ESR HORSLEY LOGISTICS PARK - SSD-10436 MOD 3

Section 4.55(2) Modification

Figure 2 Roof Level Plan – Proposed Mechanical Control Units

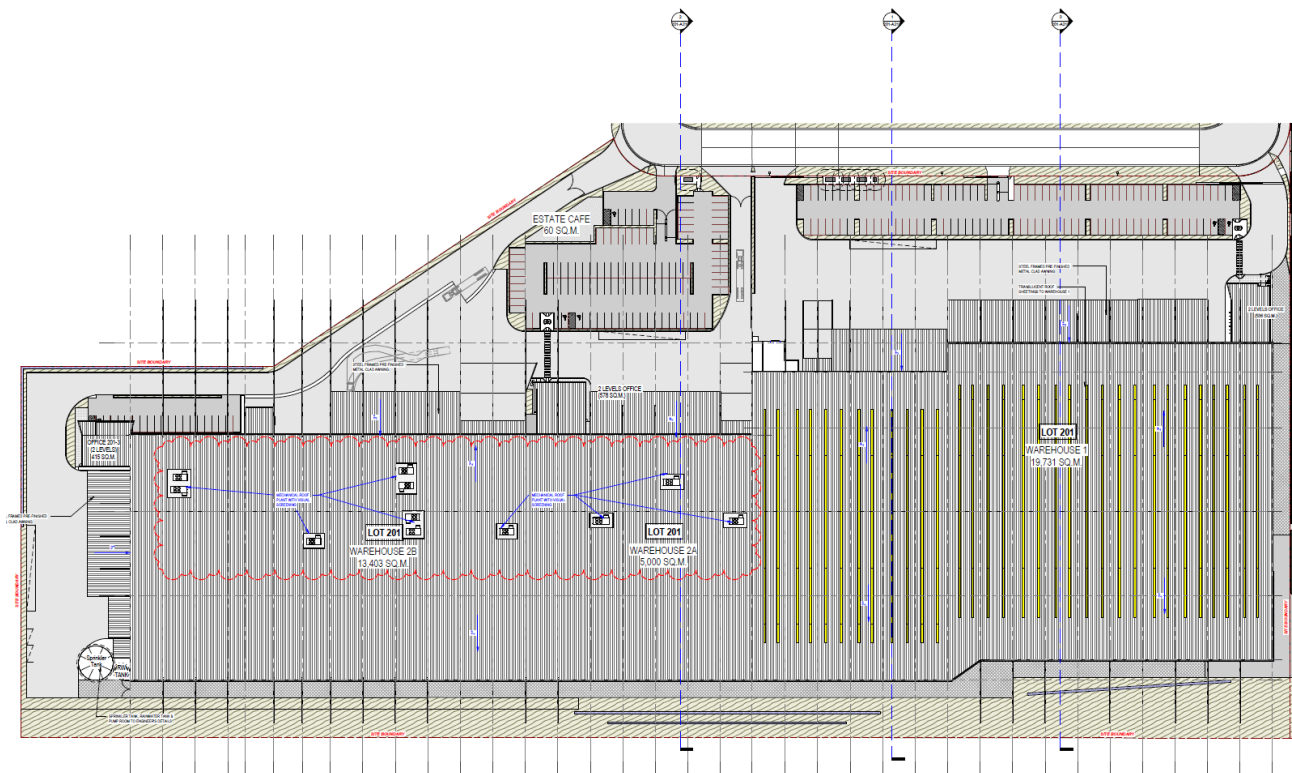
- Removal of roller shutter doors from the western elevation of the Lot 201 building.
 - To facilitate the adjusted storage space, the existing 4 flush loading docks and the four supporting roller shutter doors are to be removed from the west end of the Lot 201 Warehouse.

It is identified that the proposed mechanical control units are to be located at the rooftop of Warehouse 201 and will increase the maximum building height from 15m to 18.8m. Otherwise, it is noted that the approved, maximum ridge height of the warehouse of 101.7m RL will remain unchanged from the original design. These units will have a maximum dimension of 4.8m x 2.2m and the screening of this plant equipment will consist of aluminium battens in a grey tone consistent with the approved building finish and façade treatment.

Figure 3 Lot 201 Site Plan – Proposed Storage Fit-out

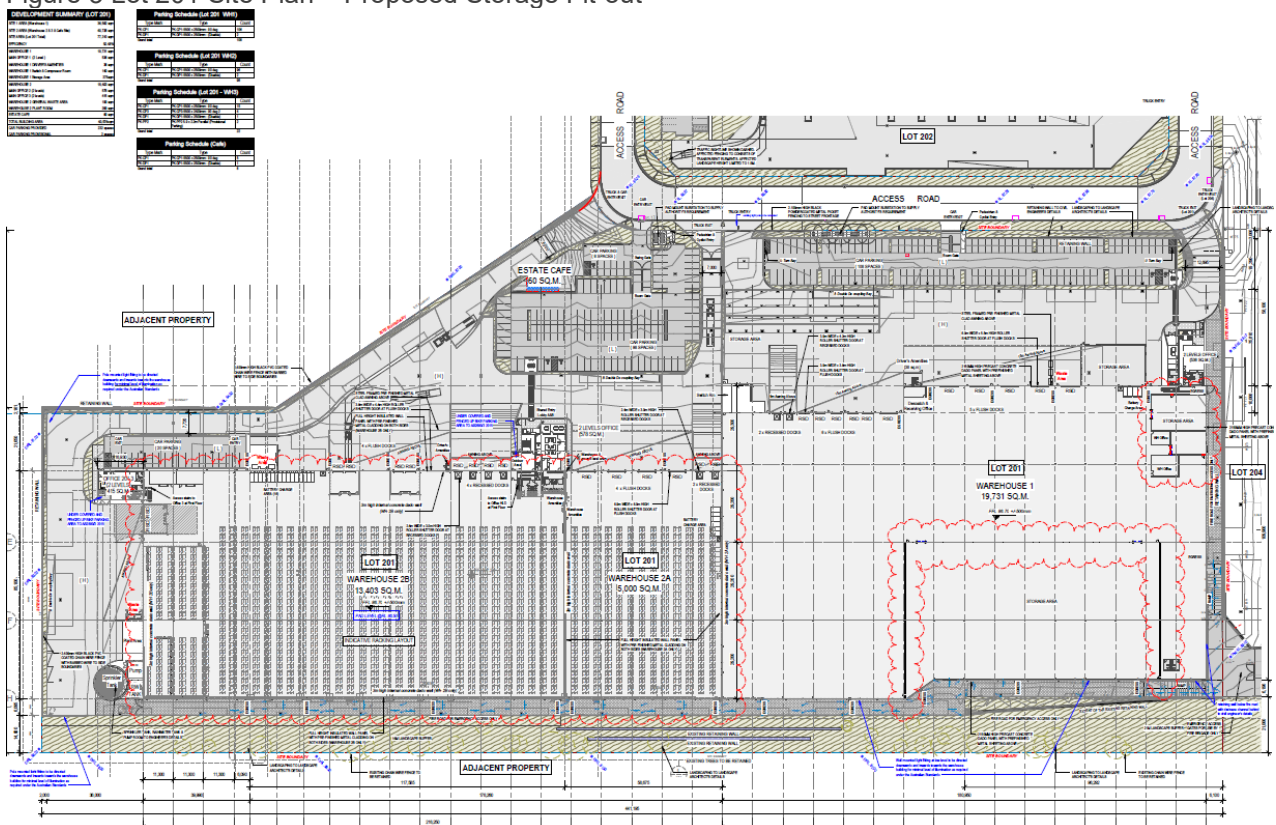
- Amalgamation of Tenancy 2B and Tenancy 3, to be identified and operate as Tenancy 2B;
- Installation of rooftop mechanical plant to support the temperature controlled elements within Tenancy 2; and
- Introduction of new storage areas and warehouse offices across Tenancy 1 and Tenancy 2;
